MASSACHUSETTS INSTITUTE OF TECHNOLOGY
HAYSTACK OBSERVATORY
WESTFORD, MASSACHUSETTS 01886
May 2, 2008

Subject: **GGAO Receive Chain Component Configuration Considerations**

Purpose: To establish an optimum component configuration for GGAO's receive chain given the available RF components.

Figure 1: Current Configuration of GGAO Receiver Cascade

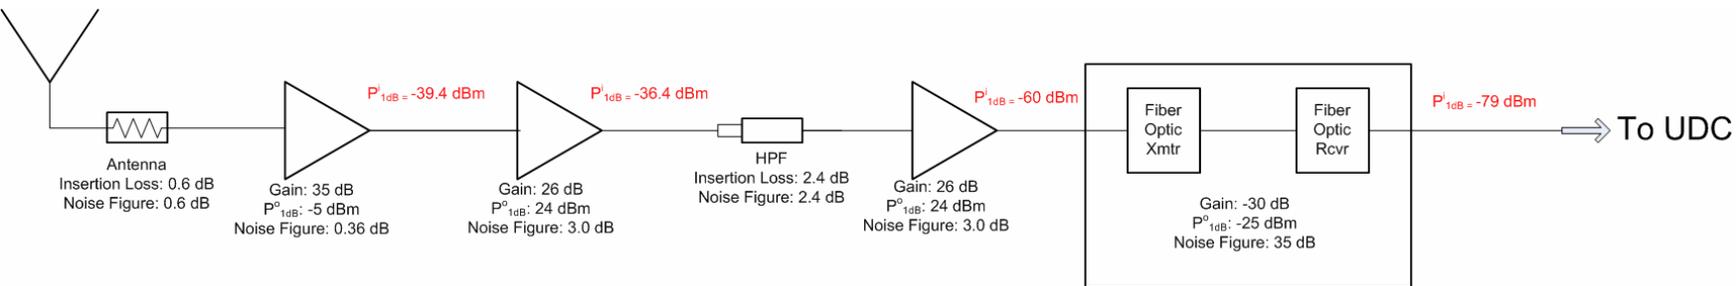
After reviewing the current receiver operating configuration at GGAO and the specifications of the components used to construct the receiver chain, the configuration was found to be sub-optimal as argued in section 5. Figure 1 displays a diagram of the receiver chain for a single polarization. The device RF parameters relevant to this memo are printed in black below each component in the figure. The gain parameter is self-explanatory and the noise figure, *NF*, of the device is related to the noise temperature, T_n, by the IEEE standard definition:

Having referred the P^o_{1dB} levels of each stage to the input of the cascade, the maximum input power limit (before the onset of saturation) of the cascade can be determined. The first stage to saturate, in the view of increasing the cascade input power level from minus infinity, imposes the limitation on the P^i_{1dB} level of the entire cascade. In observing the cascade P^i_{1dB} values (red font) in Figure 1, the fiber link saturates first, at an input level of P^i_{1dB} = *-79 dBm*. In section 3, P^i_{1dB} is compared to the effective system

Given that P^i_{1dB} = *-79 dBm* and P_{ndB} = *-81 dBm* for the cascade outlined in Figure 1, the saturation margin is Δ_s = *2 dB*. Given such a small amount of saturation margin, the cascade becomes very susceptible to saturation by RFI.

Based on the values for P^i_{1dB}, T_{sys}, and B, **the time-average source/RFI power limit for the GGAO receiver in its current configuration is P_{as1dB} = -84 dBm**. Note that this level is below the thermal noise power (-81 dBm) of the front-end. In practice, however, there are routinely RFI components that far exceed this front-end thermal noise power level based on spectra observed at GGAO. For this reason it is believed that the GGAO receiver, in its current configuration, is operating in a nonlinear (saturated) mode.

Figure 2: Proposed Configuration of GGAO Receiver Cascade

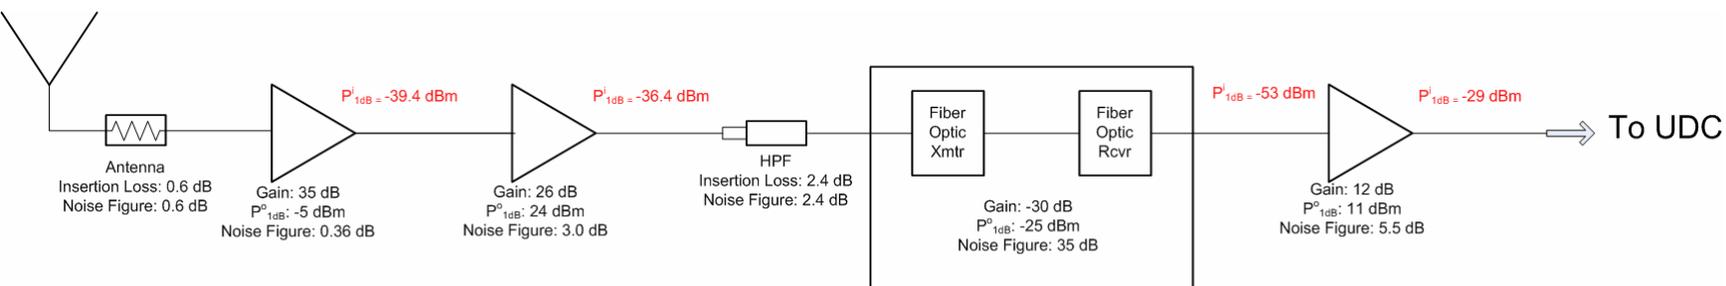
Figure 2 displays a proposed configuration of the GGAO receiver cascade designed to alleviate the small saturation margin of the cascade in Figure 1. Using equations 1-8 the performance parameters for the proposed cascade were calculated. A

comparison of these parameters for the current and proposed configuration is displayed in Table 1. **By simply removing the second 26 dB amplifier and adding a 12 dB amplifier at the output of the cascade significant improvement in the saturation margin** (to $\Delta_s = 28\ dB$) **and RFI handling** ($P_{as1dB} = -53\ dBm$) **of the cascade is gained at the cost of only** *2.7K increase in the system noise temperature* (*52.7 K*). Furthermore, with the receiver in this configuration, the thermal noise output of the cascade is *-40.6 dBm* which is the appropriate input level to the UDC per my conversation with Alan Rogers.

Lastly, the saturation margin of a receiver cascade is reduced when the P^o_{1dB} of a particular device in the cascade is not matched to the input P_{1dB} of the component following it. The P^o_{1dB} level of the cascade in Figure 1 is (*-25 dBm*) while that of Figure 2 is (*-13 dBm*). Because the P^o_{1dB} of the proposed cascade matches the input P_{1dB} of the UDC (*-12 dBm*) more closely than the P^o_{1dB} of the current driver, Figure 2 represents a better driver of the UDC.
